CPSES-200200025  
Log # TXX-02004  
File # 10010

March 4, 2002

**SUBJECT: COMANCHE PEAK STEAM ELECTRIC STATION (CPSES)  
DOCKET NO. 50-446  
UNIT 2 INSERVICE INSPECTION (ISI) A-4 THROUGH A-8 RELIEF  
REQUESTS FROM 1986 EDITION OF ASME CODE, SECTION XI,  
NO ADDENDA**

**ADDITIONAL INFORMATION REQUESTED FOR UNIT 2  
INSERVICE INSPECTION (ISI) A-4 THROUGH A-7  
RELIEF REQUESTS FROM 1986 EDITION OF ASME  
CODE, SECTION XI, NO ADDENDA**

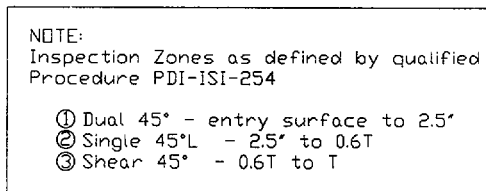
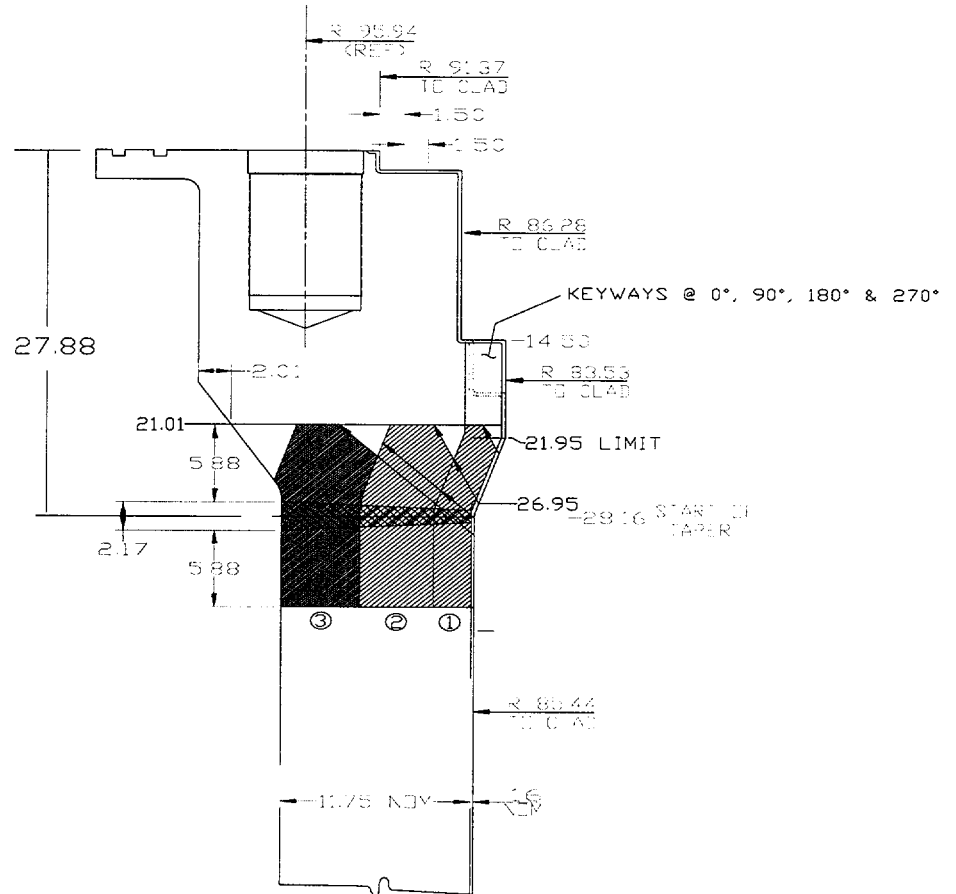
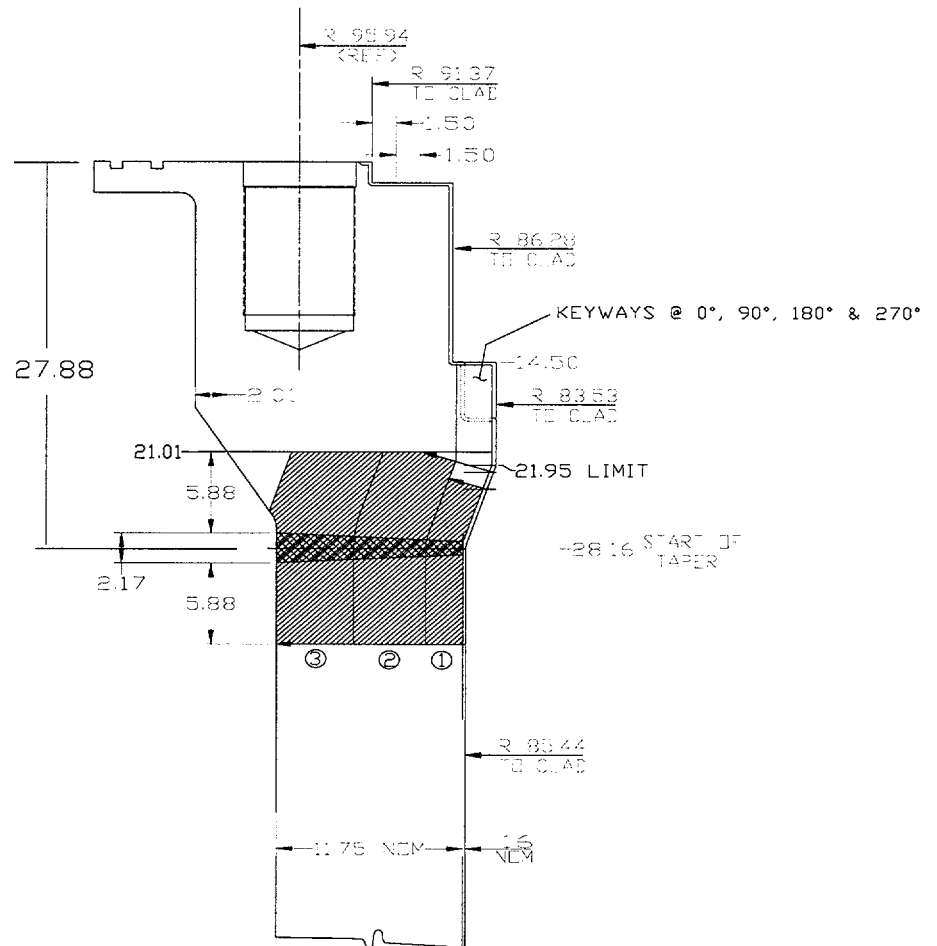
- B. Is the weld accessible to examination from all scan directions? Provide drawing(s) showing access from all scan directions? Is the licensee able to examine the weld on both sides?

Yes, refer to Figures 1 through 3.
